Informal document GRSP-75-18
GRSP 75th session, 27th – 31st May 2024
Agenda Item 13

Ensuring CRS compliance with UN R129 - Update

Submitted by the experts from CLEPA

CRS 1 (EX Type-approval)

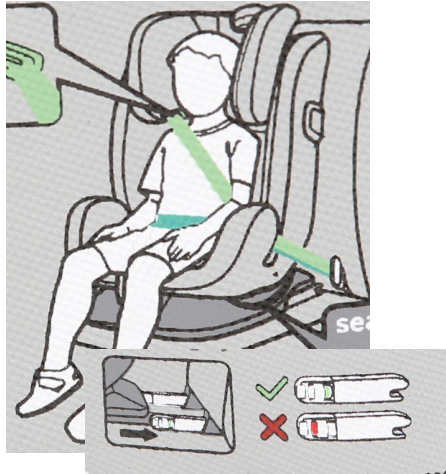
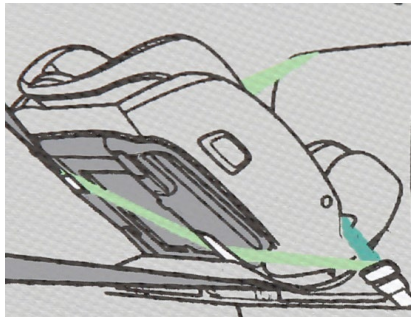
Belt route 1: Belt-attached integral
(Child: 40-105 cm)

Belt route 2: Belt-attached integral
(Child: 100-145 cm)

- Two belt routes (para. 3.2.2)
- Non-ISOFIX attachments (para. 6.1.3.2)
- ‘ISOFIX’ on belt-attached integral/booster combination (para. 3.2.2.)
